Cogentrix Quail Brush Generation Project - Docket Number 11-AFC-3, Response to Dorian Houser's Intervenor Data Requests, 28, 29, and 30

***APPLICATION FOR CERTIFICATION FOR THE
QUAIL BRUSH GENERATION PROJECT***

**FIGURE 1
EXISTING INFRASTRUCTURE AND ZONING
FOR A NATURAL GAS PEAKER PLANT WITHIN
SDG&E SERVICE AREA**

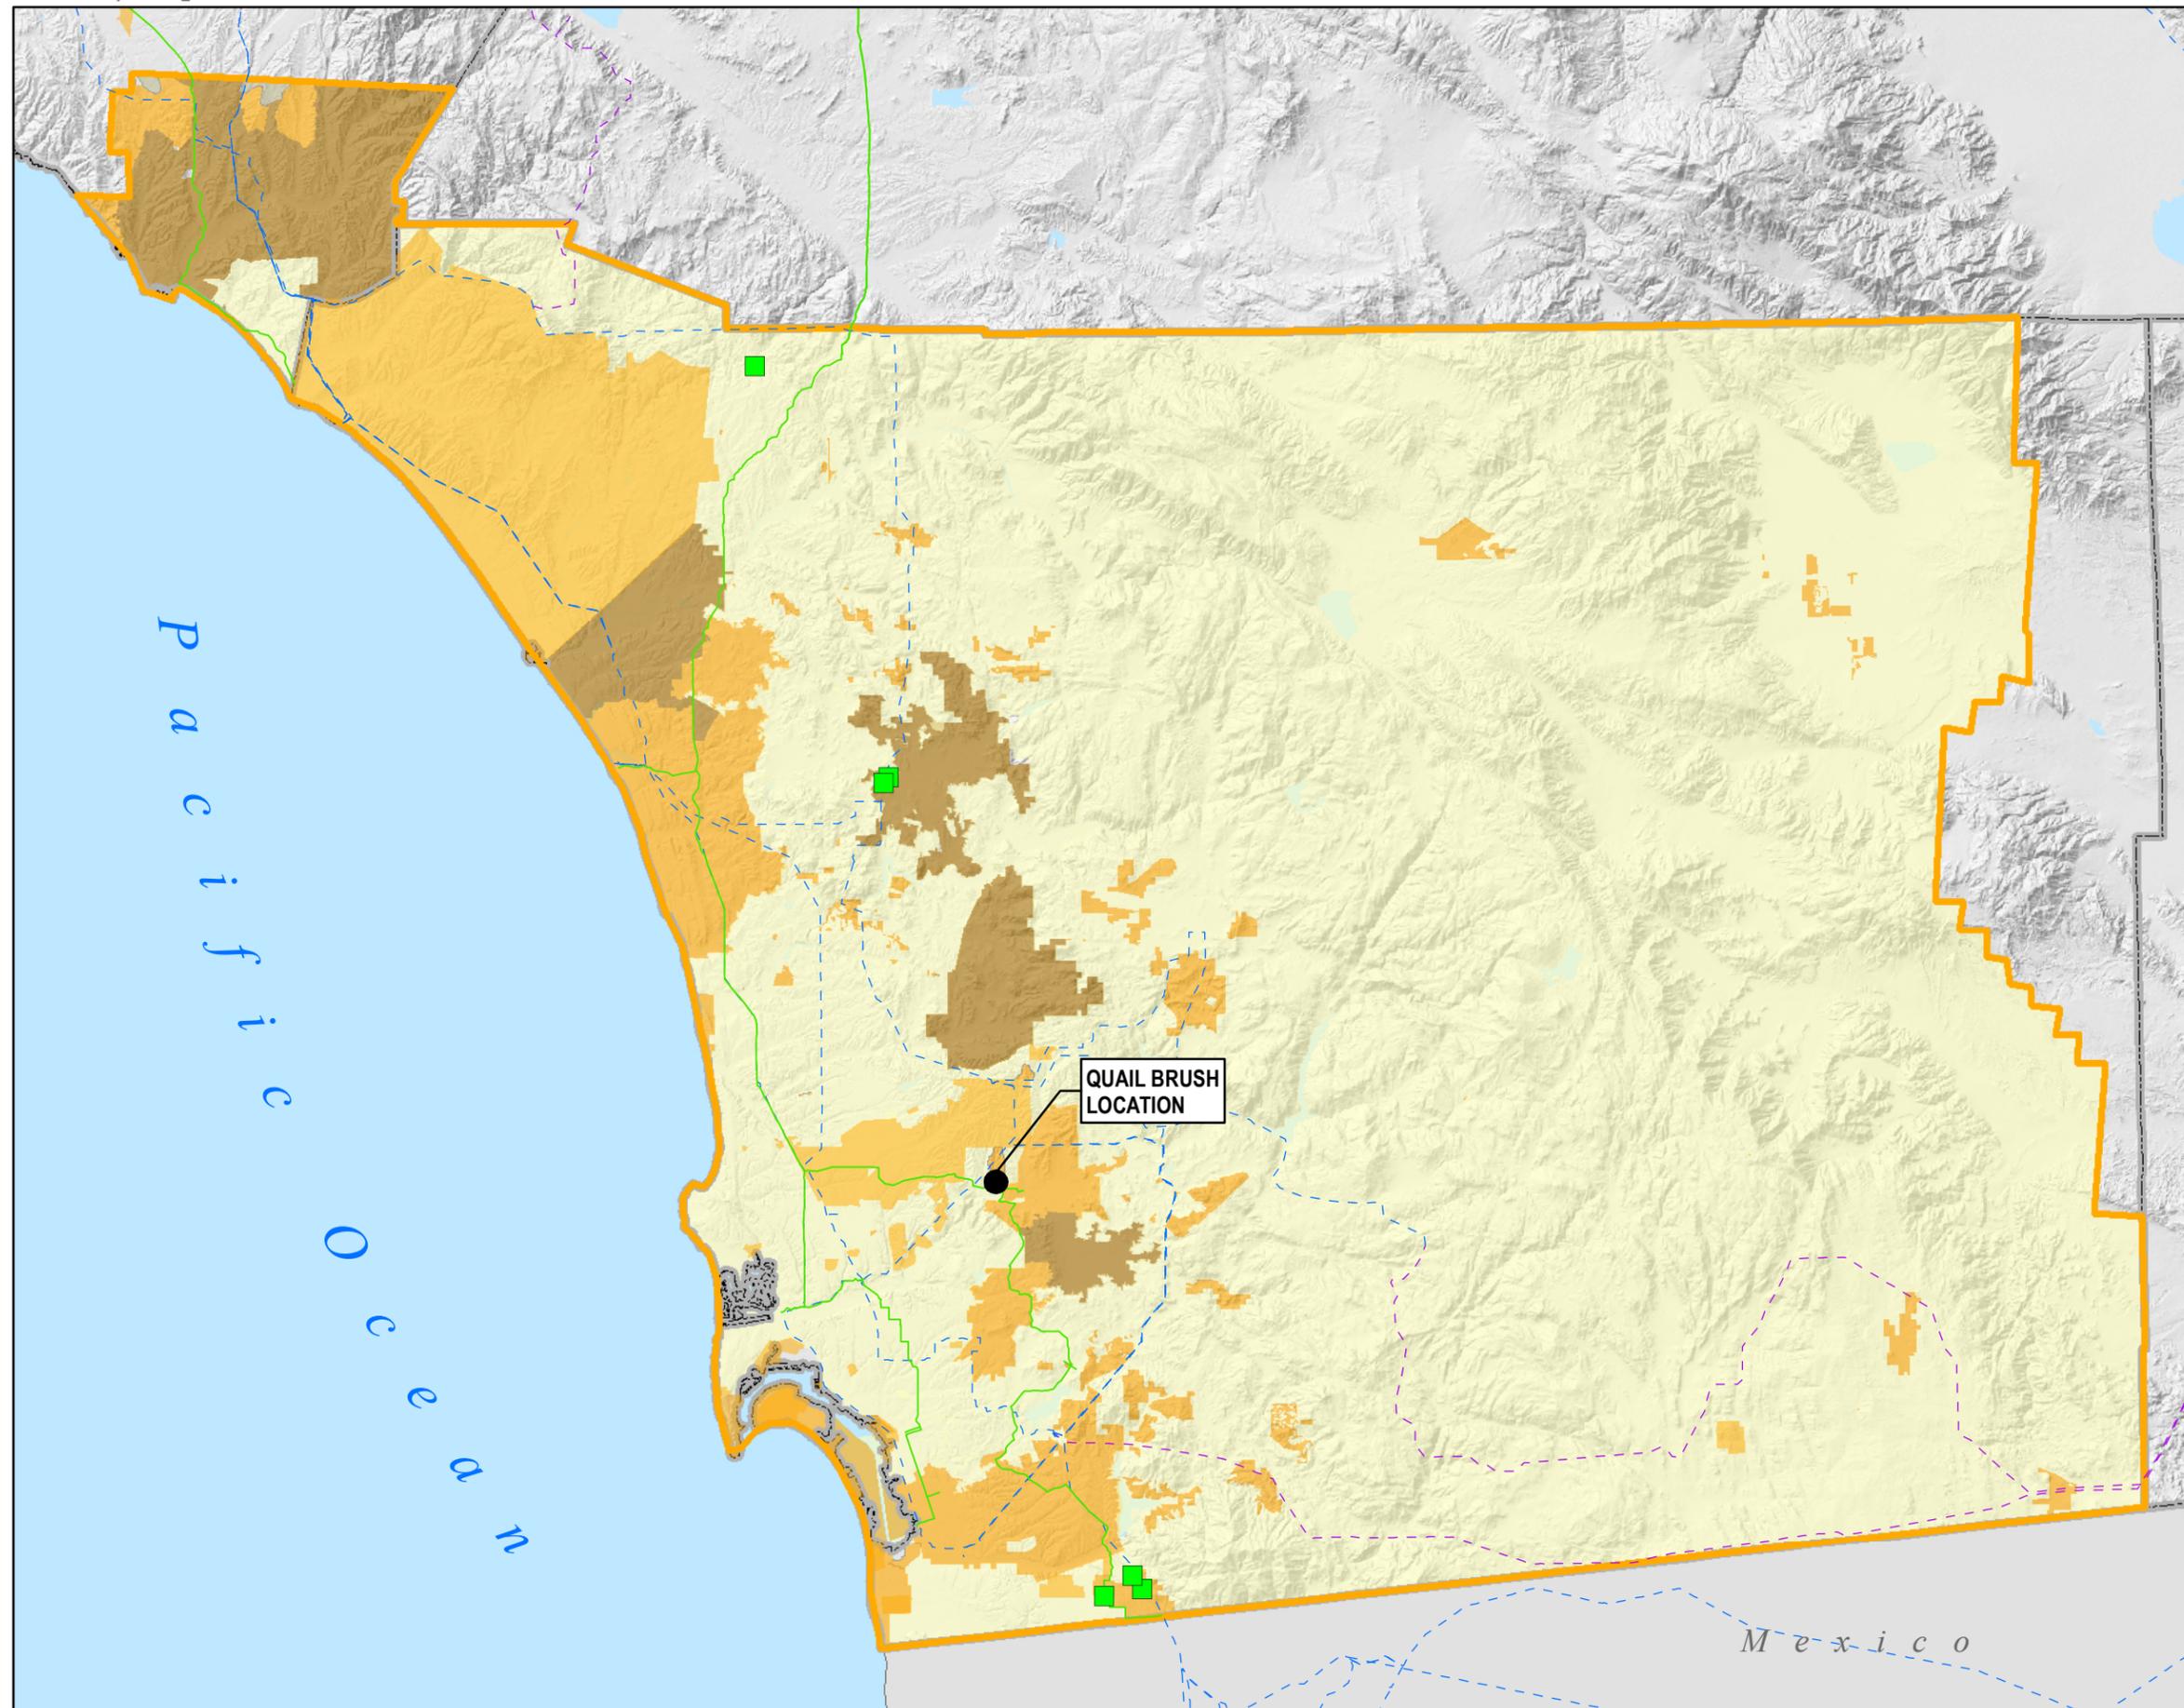
28. Data Request: Please provide a map of the SDG&E territory with overlays displaying the following features: 1) property zoned appropriately for operation of the proposed facility; 2) the location of existing natural gas lines; 3) the location of transmission lines; 4) and the location of other natural gas power generation facilities, whether active, slated for retirement, or retired.

The requested map is included as Figure 1. Figure 1 was developed by identifying all of the jurisdictions within the SDG&E service territory, reviewing the zoning ordinance of each jurisdiction to identify zone districts that are zoned appropriately for operation of the proposed facility, and determining whether GIS data of the zone districts is available. Figure 1 does not show where a power plant is allowed by right, but rather where it may be allowed if it met the various requirements to obtain a conditional use permit. Much of this area is within the unincorporated areas of San Diego County. Figure 1 includes three categories: zone districts that would allow the project under a conditional use permit, property not zoned appropriately for operation of the proposed project, and data not available.

The CEC website http://www.energy.ca.gov/sitingcases/all_projects.html provides information for all of the power plants in California over 50 MW since 1996. This list was narrowed to include operational power plants within the SDG&E service territory; these power plants are included on Figure 1. Note that information regarding power plants that are slated for retirement or retired and power plants that are less than 50 MW could not be found online and therefore are not included on Figure 1.

This information is plotted on Figure 1 as well as the location of existing natural gas pipelines 20 inches in diameter or greater and high voltage transmission lines.
